Nelson Christensen  
3-28-90

### Sensitivity to a Stochastic Gravitational Radiation Background Using Dual Recycling Fabry-Perot Interferometers

The purpose of this memo is to point out an error in Figure A-4c of the LIGO proposal. This figure shows the expected sensitivity to a stochastic gravity wave background using the early LIGO detector, the advanced LIGO broadband recycling detector, and the advanced LIGO resonant recycling detector. The plot for the dual recycling envelope is wrong, and this memo will explain why.

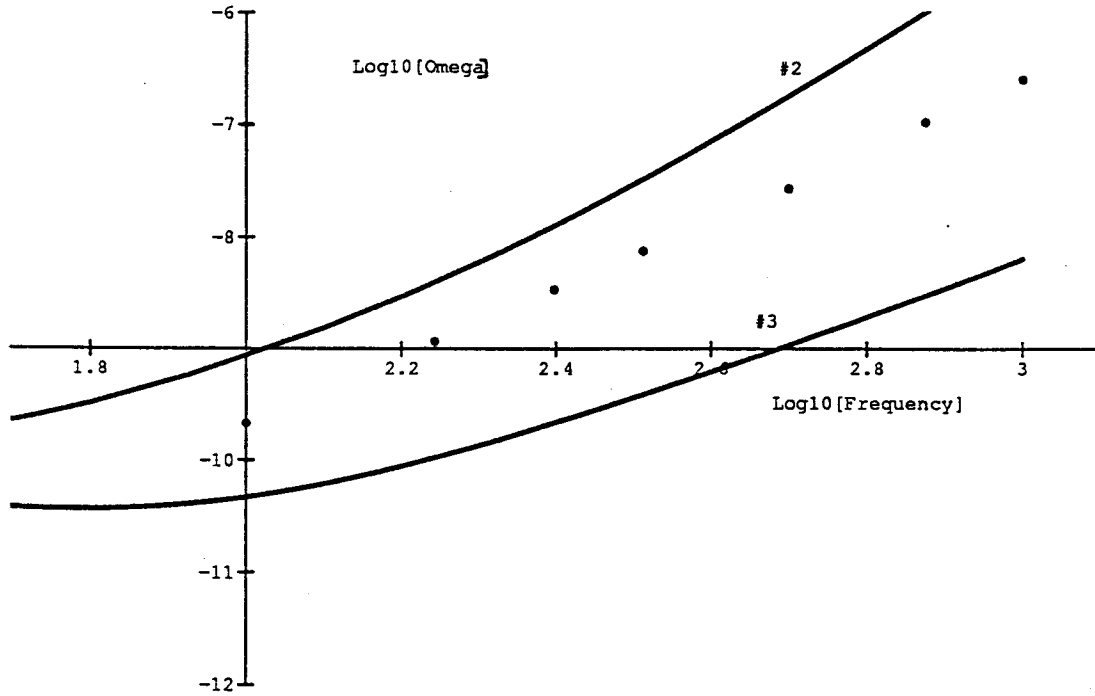
The bottom line is that for dual recycling the effective bandwidth is much smaller than the frequency where the measurement is taking place. Figure 1.1 shows the result of this. The sensitivity of the advanced recycling Fabry-Perot (#2) and the advanced dual recycling Fabry-Perot (#3) systems according to the approximation  $\Delta f=f$  are plotted against  $\Omega_{gw}$ . The dots show the result when the optimum filter output is properly integrated over frequency. Therefore, the actual dual recycling limit is not quite as good as what one would normally think.

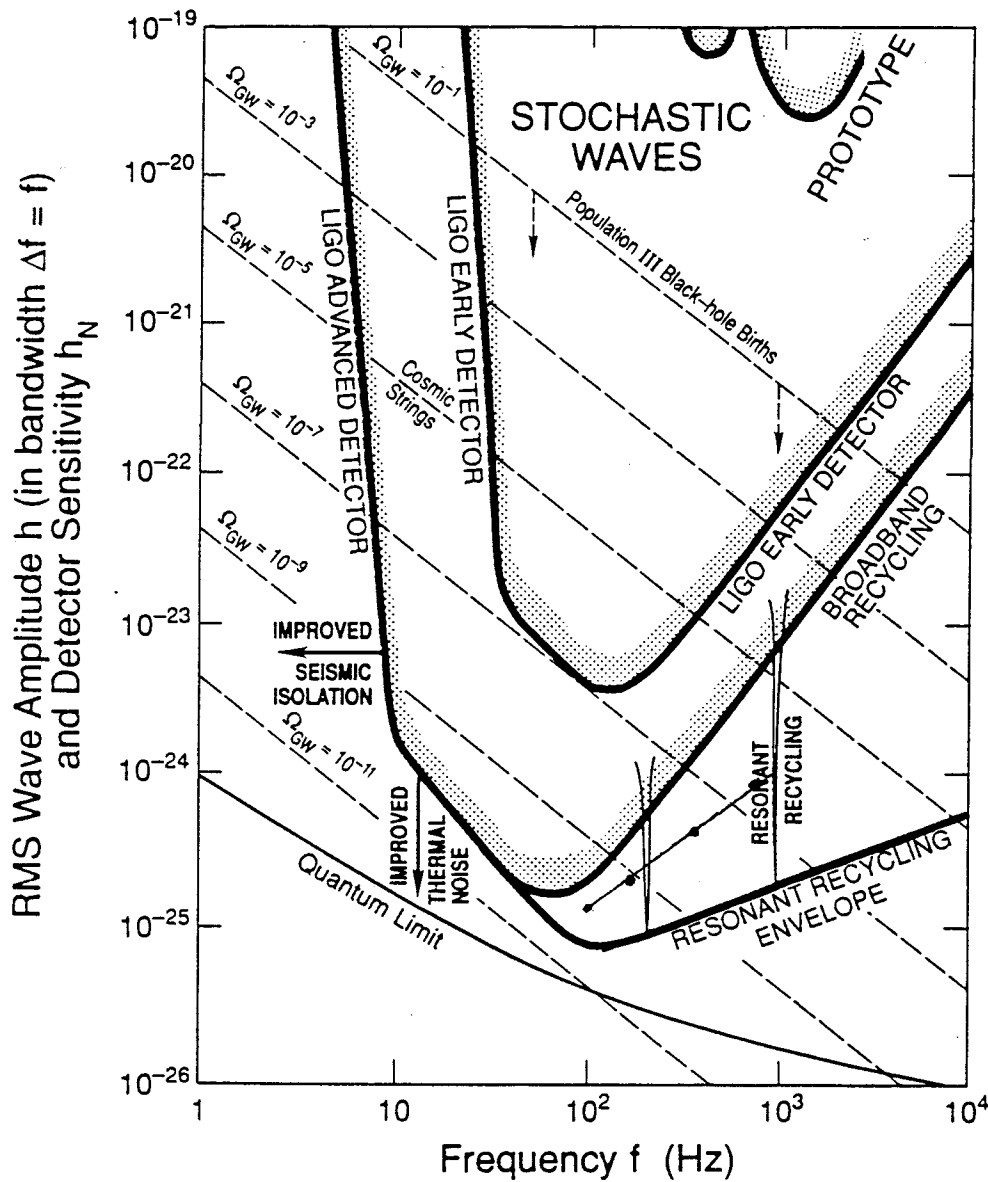
The integration has been approximated over a band  $\Delta f$ . For Figure A-4c of the proposal one assumes that the bandwidth of the measurement  $\Delta f$  is about the same as the frequency at which the measurement is concentrating. This is an approximation that works well for broadband detection, but it isn't necessarily correct for a narrowband measurement, like dual recycling. With dual recycling, a measurement centered somewhere in the hundreds of Hertz will have a full width at half maximum for the transfer function of tens of Hertz. Remember, when optimum filter techniques are applied to the outputs of each antenna, then
